## EV AT 20-01 Version 1

**FROM** Eurovinil – Technical Dept.

**SUBJECT** EV Leisure rafts – Replacement of PRV valve type VSP-EV/08.

**FIGURE 01 – Release of VSP-EV/08 valve body**

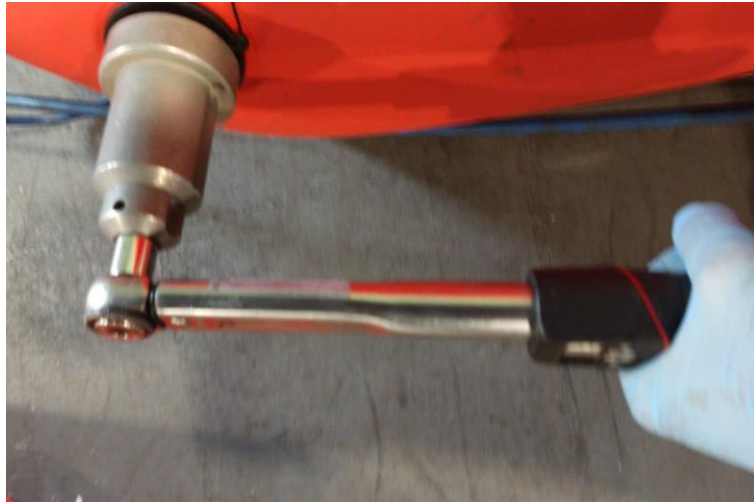
- (1) At liferaft inflated, unscrew the valve body by means of spanner P/N 99220486 (FIGURE 01).
- (2) When released, remove the valve body, external to the buoyancy (FIGURE 02).
- (3) Extract the ferrule from the buoyancy through the valve hole (FIGURE 03).
- (4) Discard the complete valve VSP-EV/08 (valve body and ferrule).
- (5) Put VA70 valve ferrule inside the buoyancy through the valve hole (FIGURE 04).
- (6) Apply gasket and cap on VA70 valve body (FIGURE 05).
- (7) Center and tighten VA70 valve body firmly by hand (FIGURE 06).
- (8) Inflate the buoyancy tube and progressively tighten the valve with tool P/N 99220796 until 25 Nm coupling torque is reached (FIGURE 07).
- (9) Perform PRV and Working Pressure test on the buoyancy tube.
